TO:  
Please quote the following parts and best delivery.

Unless otherwise specified 0.XX = +/- 0.010 0.XXX = +/- 0.005	303 Stainless Steel	LIGO- CALTECH - MIT
Do Not Scale	Size B	Drawing No. D970615 Drawing No. D000001-00-D PAM SCREWS-
Break all sharp edges .010

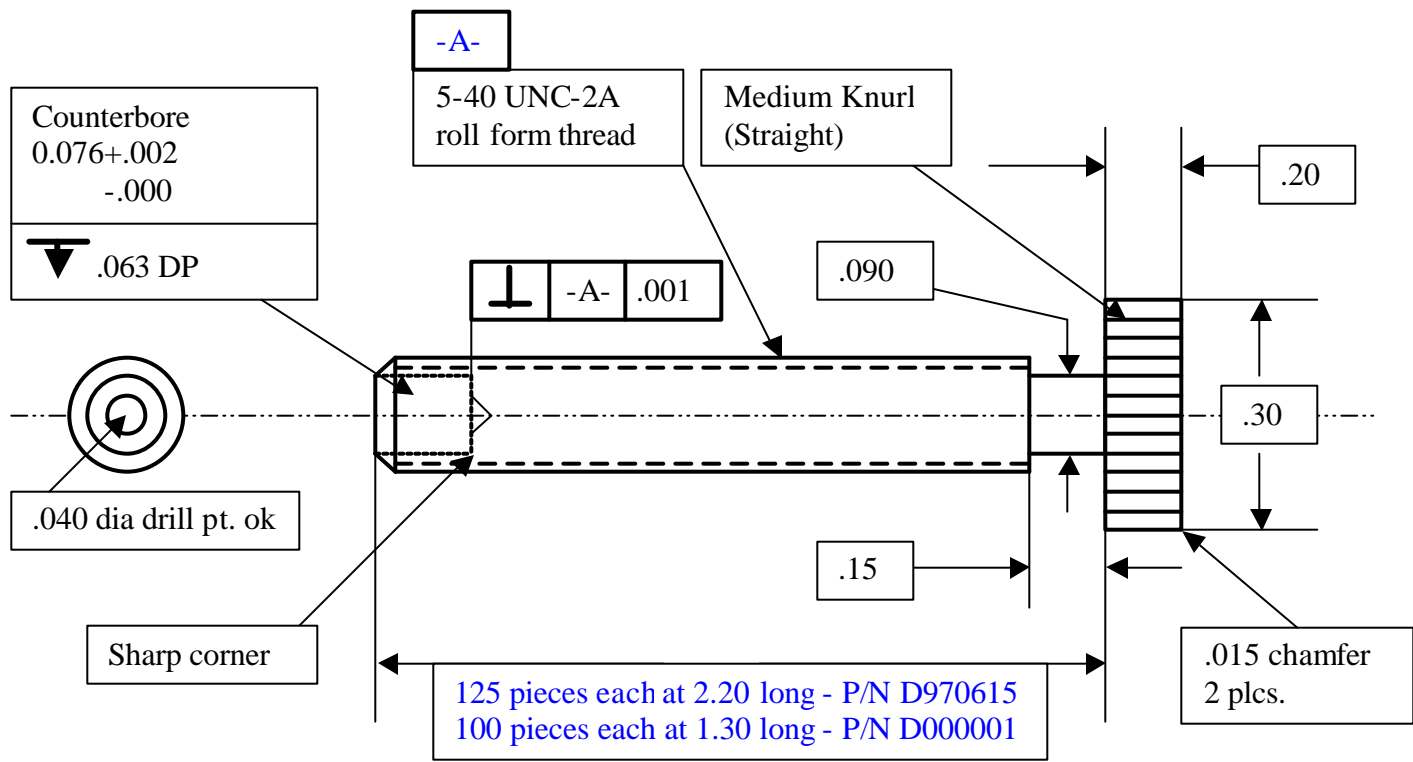
**NOTE: Blank out dimensions prior to thread rolling**

- 1/ Counter bore after thread rolling.
- 2/ Turn thread major diameter to .118+/- .002.
- 3/ Extend knurl Dim.to .300+/- .020 long for knurling.
- 4/ Protect threads during finish machining.
